TOWN OF BOXFORD

HVAC, Exterior Repairs, Library Renovation
Town Hall/Library
7A Spofford Road
Boxford, MA

ADDENDUM NO. 1 AUGUST 13, 2020

Project No.: 699.1

A501

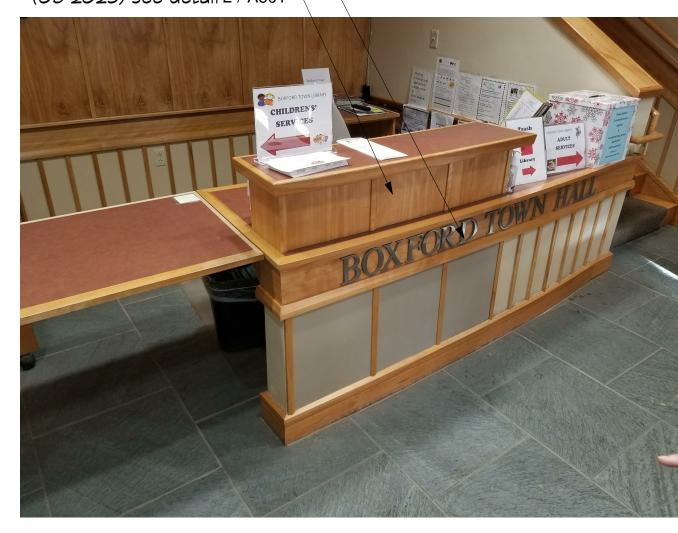
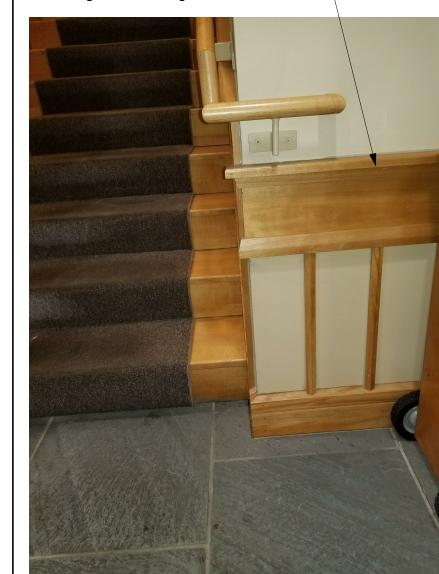
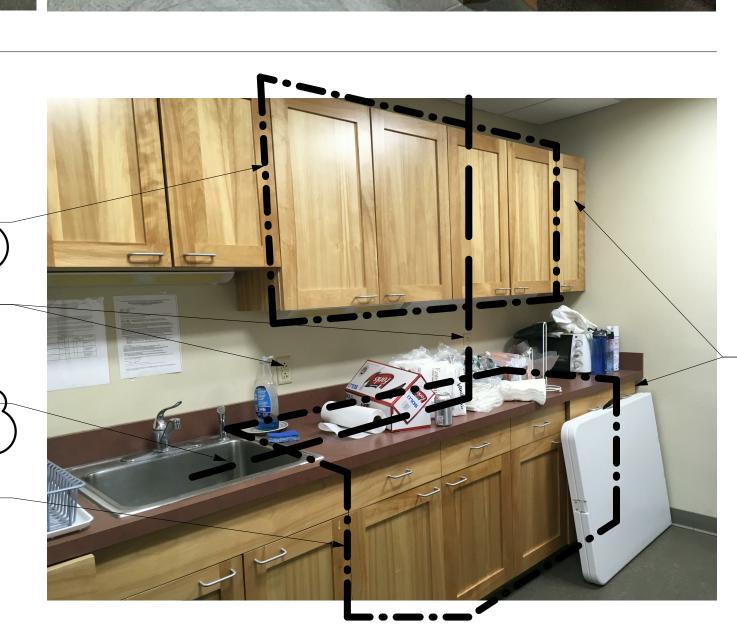
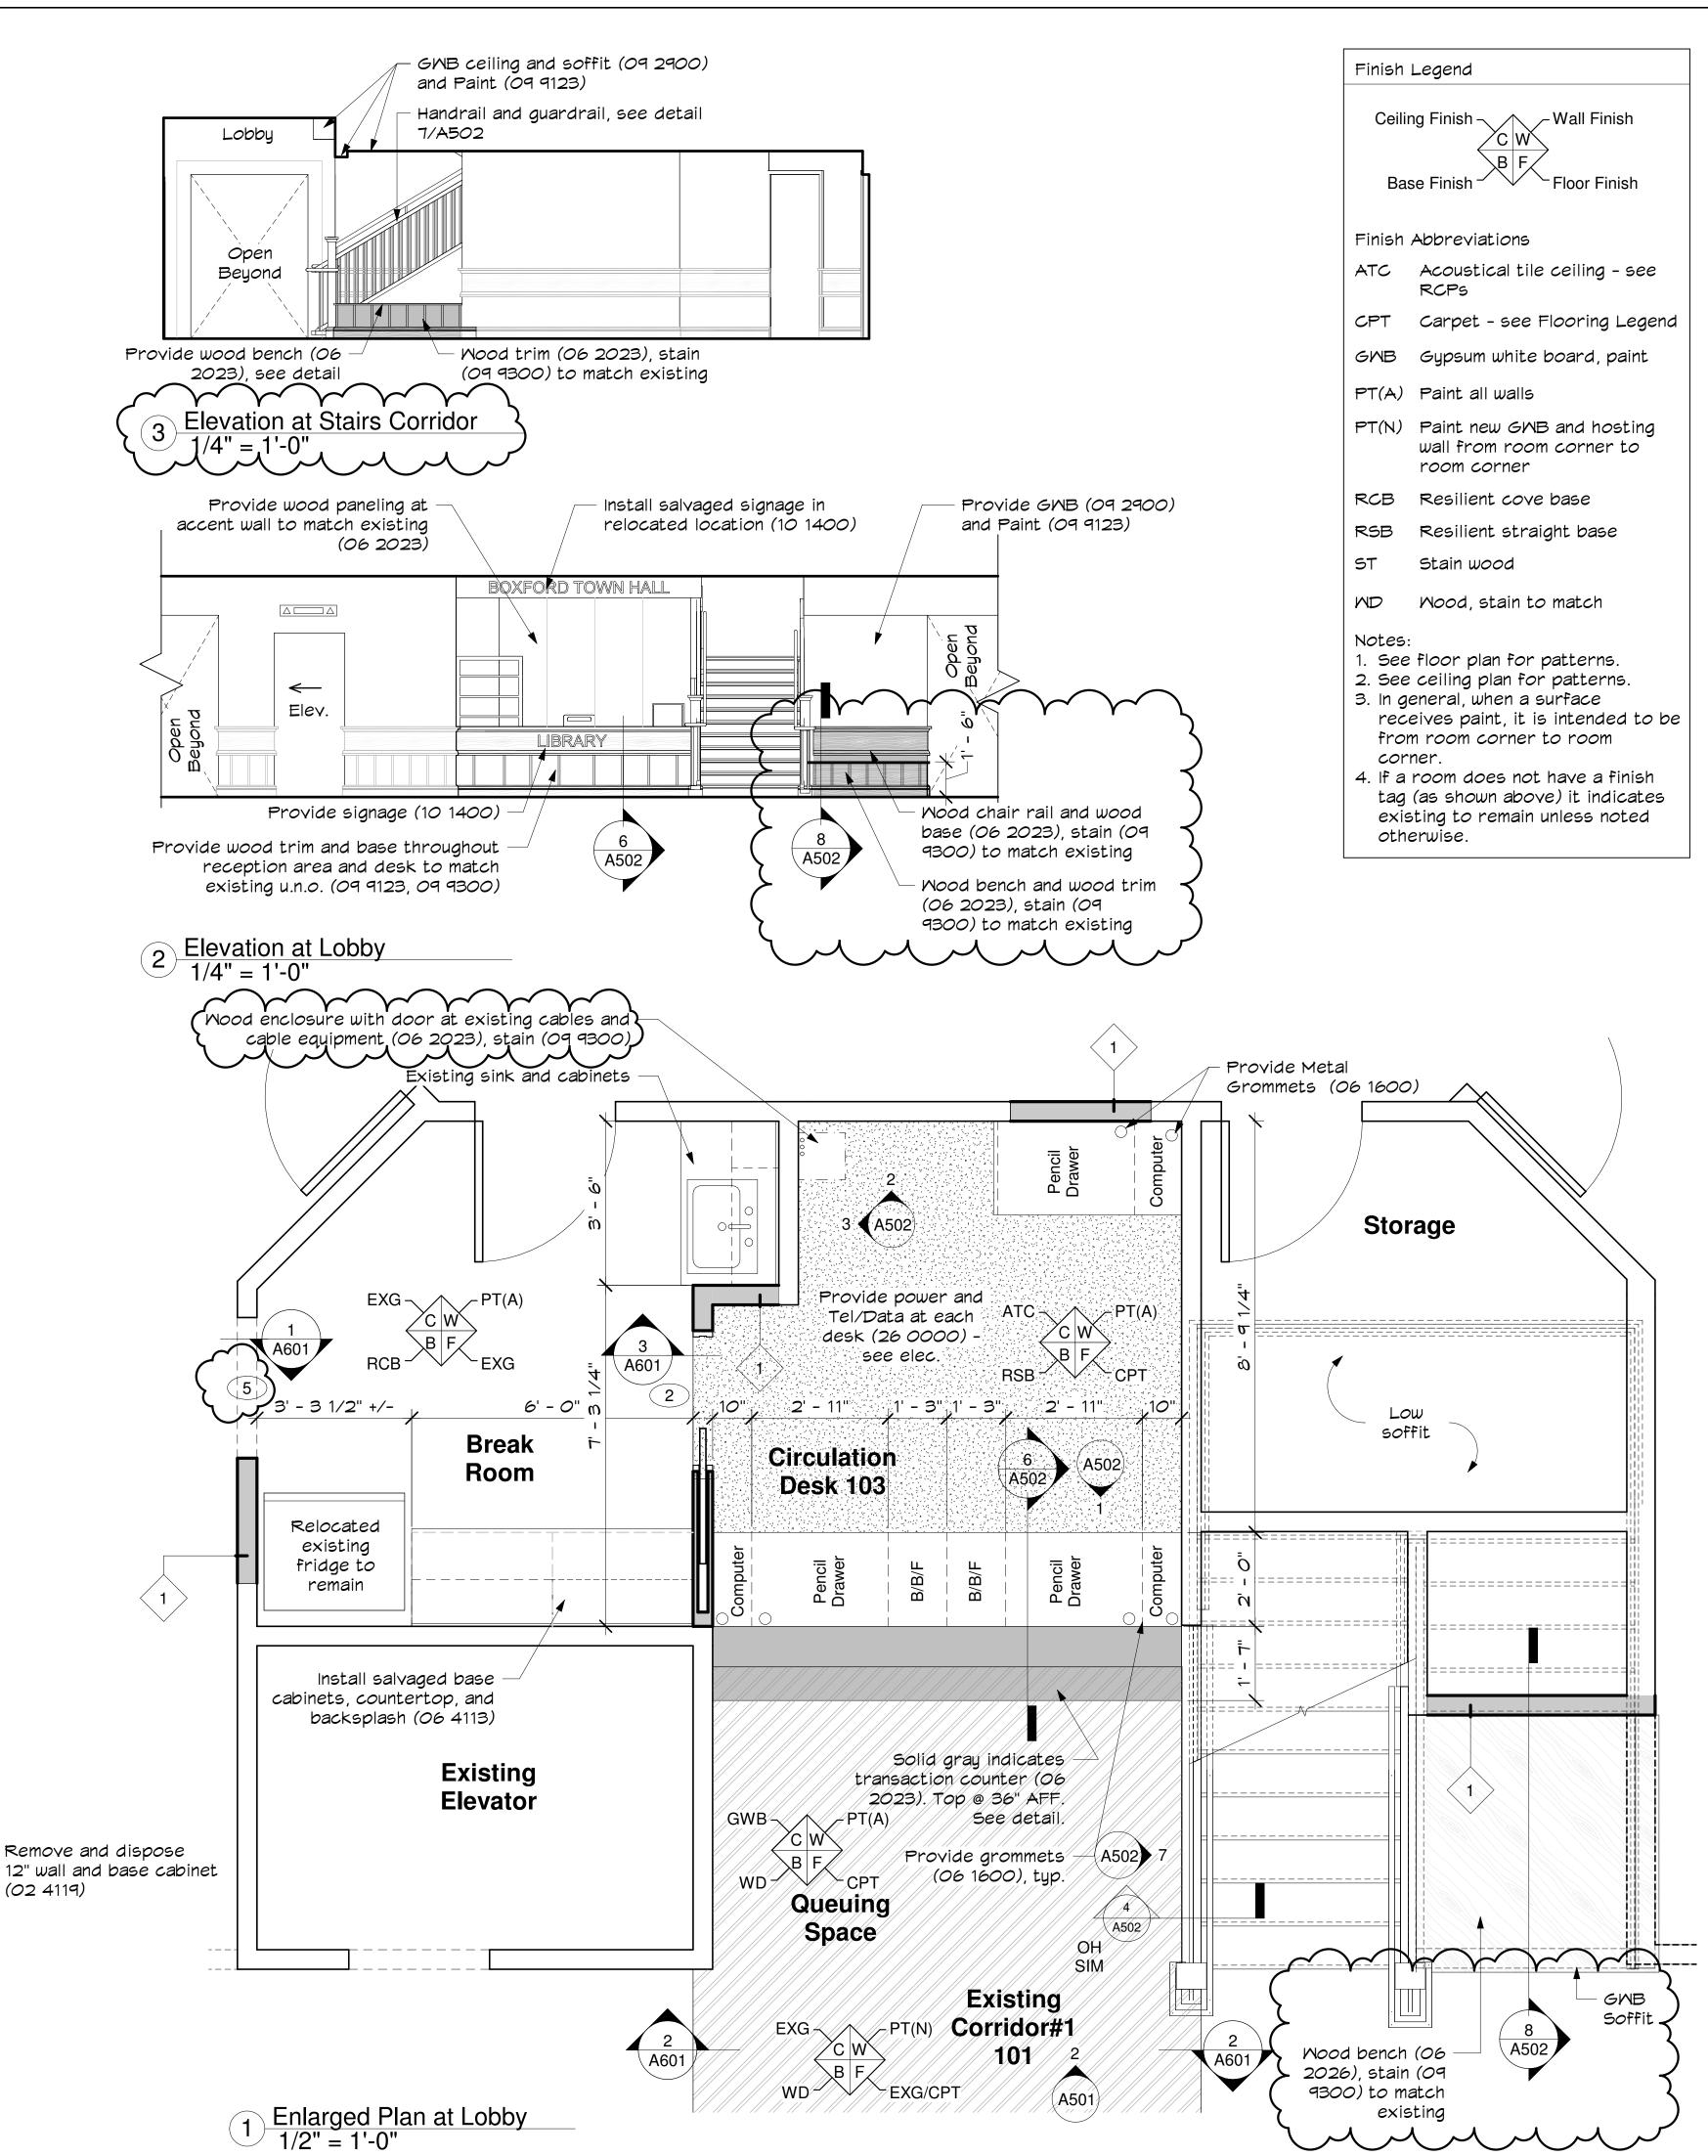
7.1. ADD, REPLACE, and OMIT notes as indicated on enclosed A501.

H-0

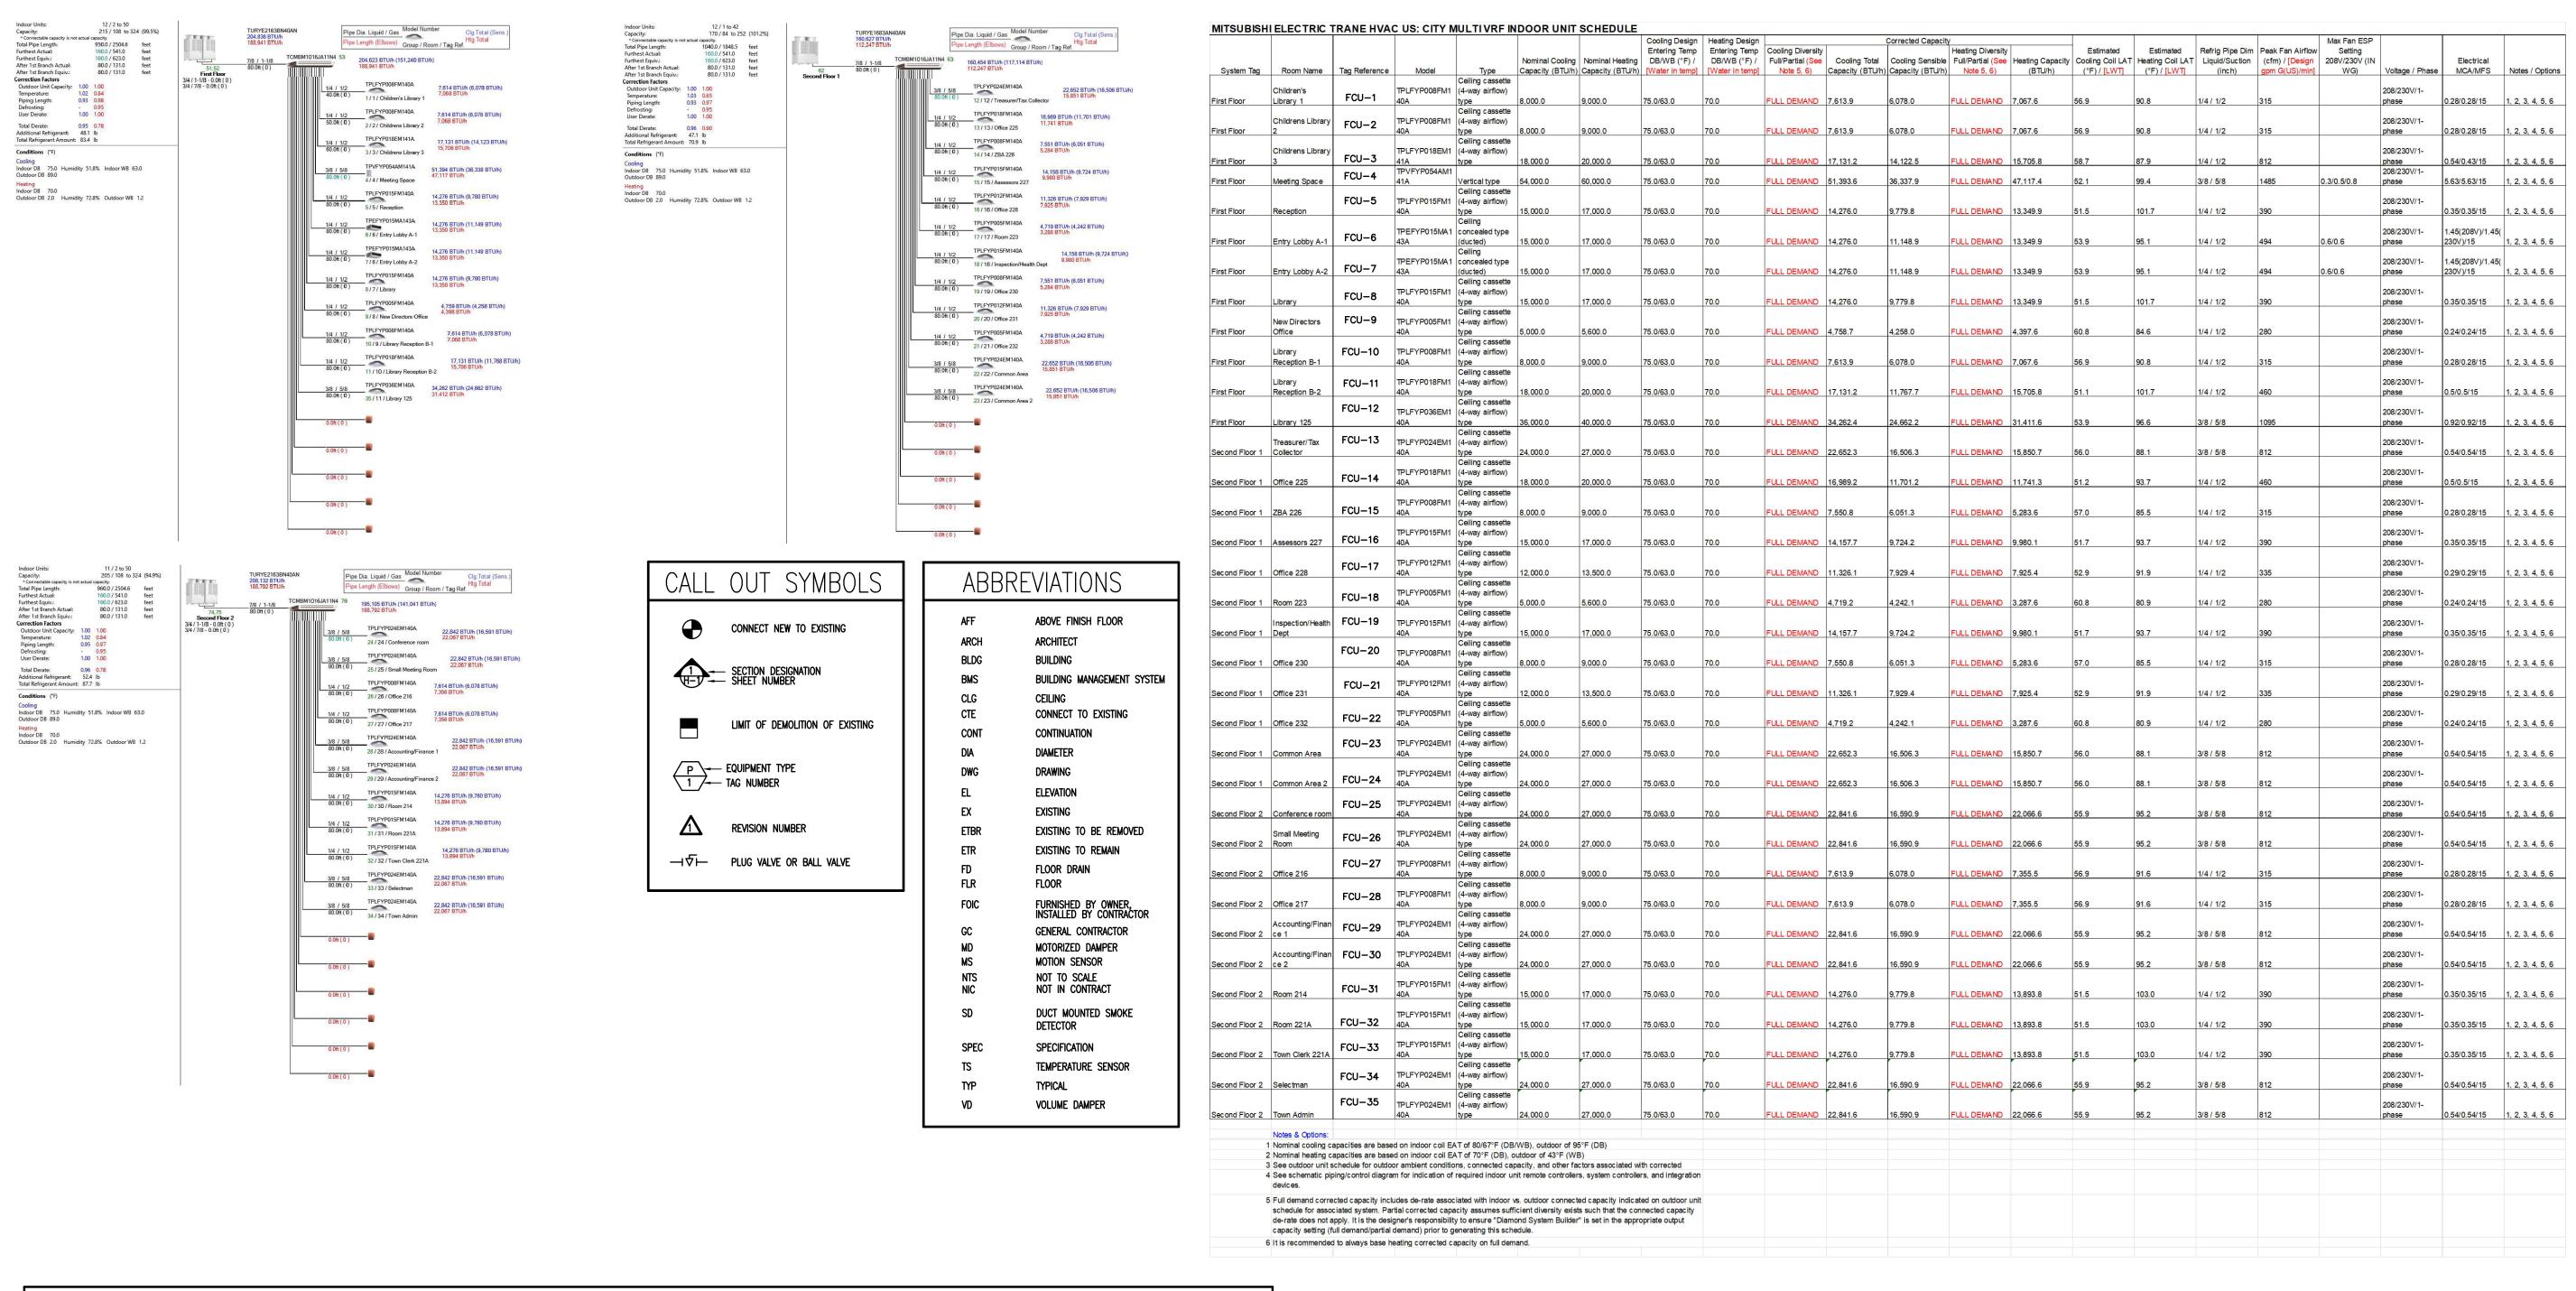
8.1. ADD sheet "H-0" as enclosed.

PARTIAL POWER RISER DIAGRAM N.T.S.

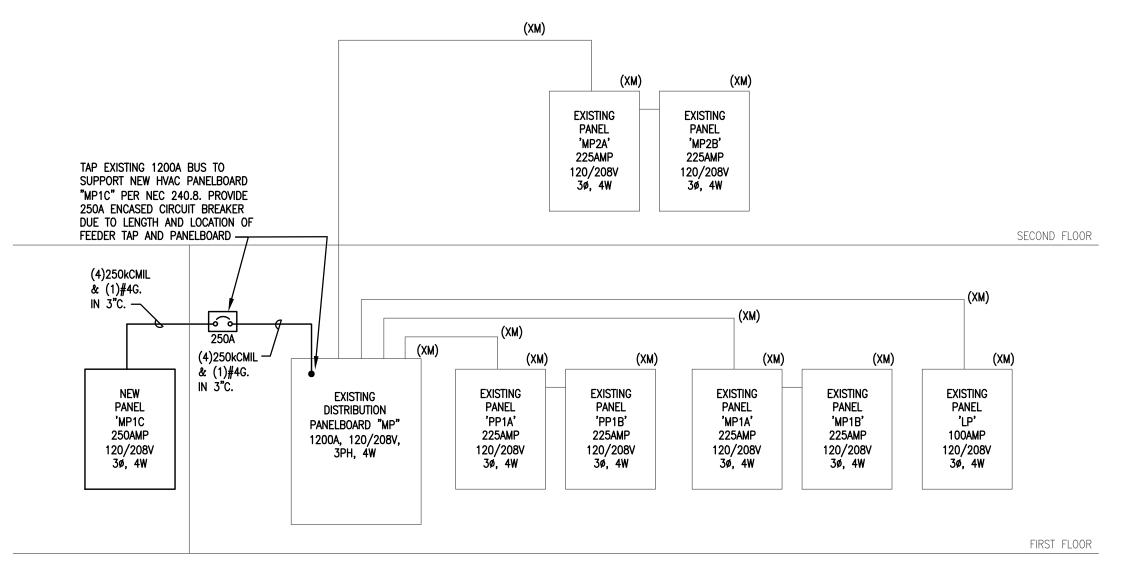
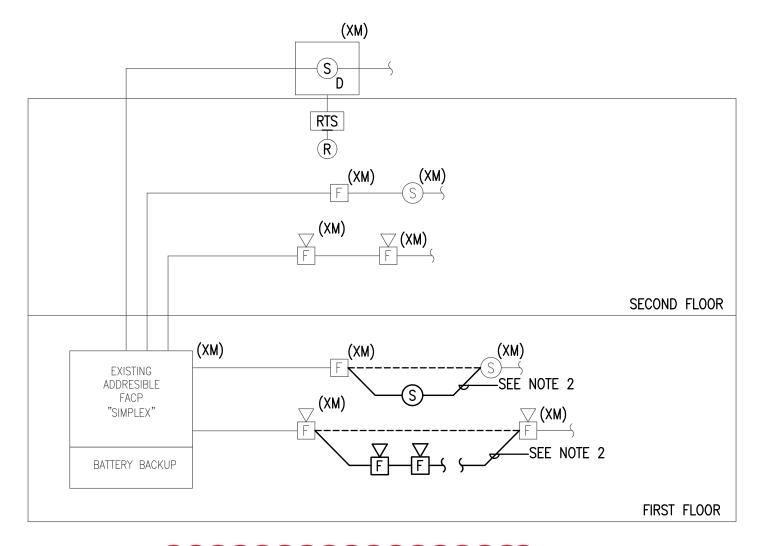
- 10.1. ADD Fixture Type "B" and Fixture Type "C" to the "Lighting Fixture Schedule" as shown on the enclosed E0-2.
- 10.2. ADD "Fire Alarm Riser Diagram" as shown on the enclosed E0-2.
